FLYING HORSE NORTH

**IRRIGATION WELL, PUMP STATION
AND RESERVOIR EMBANKMENT**

DESIGN REPORT

30% SUBMITTAL

DRAWN BY MAW (H) 1"= 2" SHEET 9 OF 12

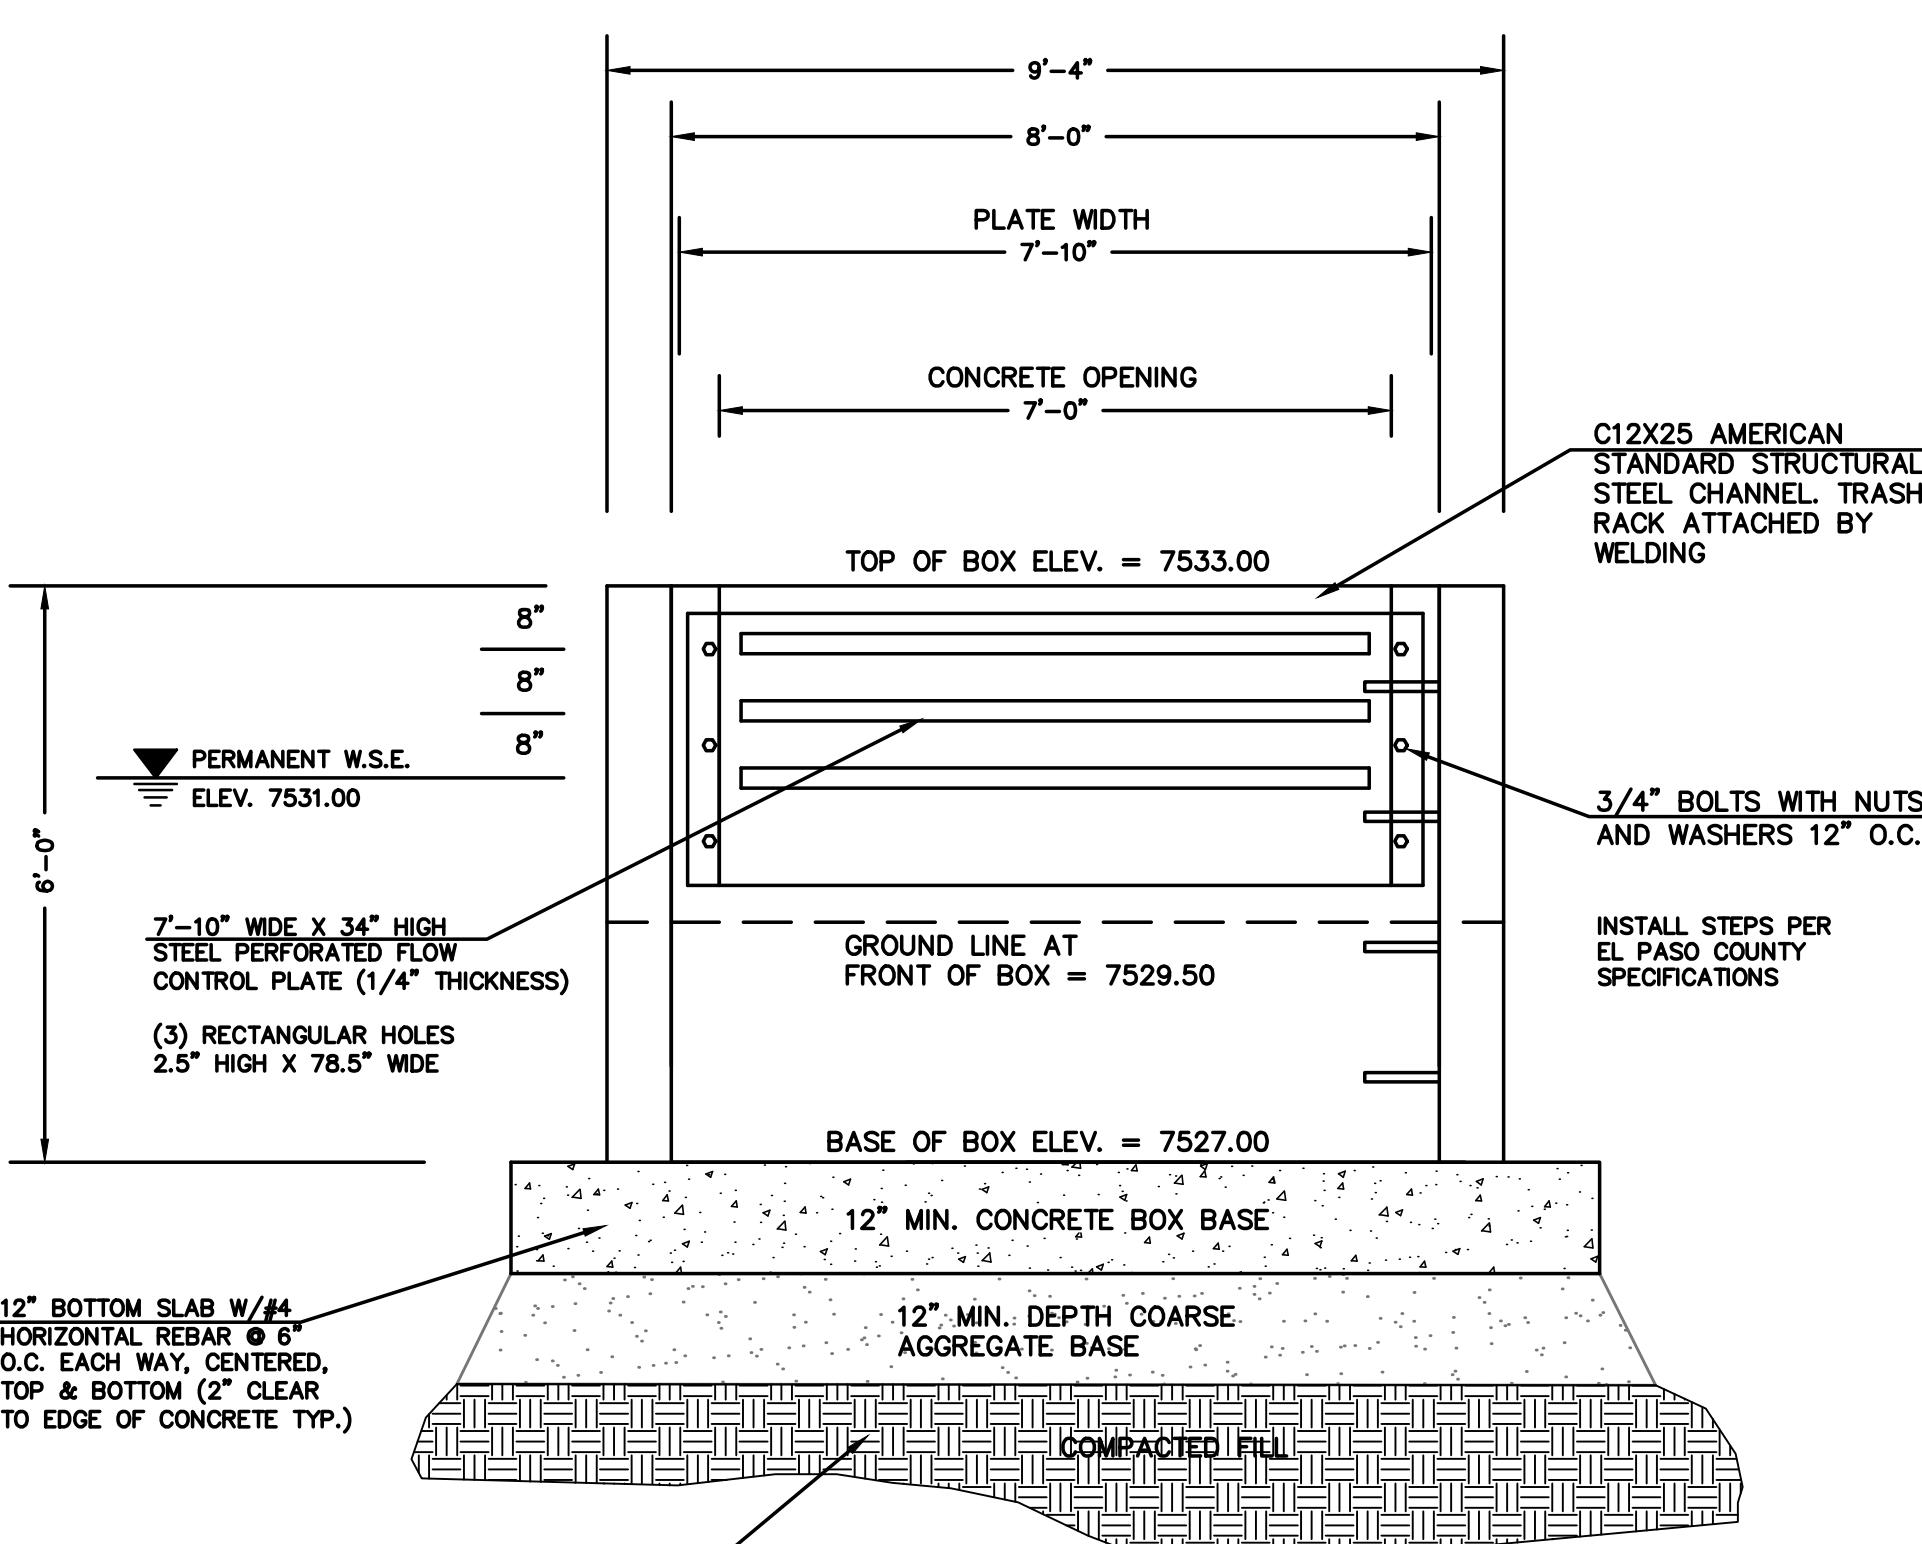
Invert of outlet pipe
does not match the
UD-Detention
worksheet.
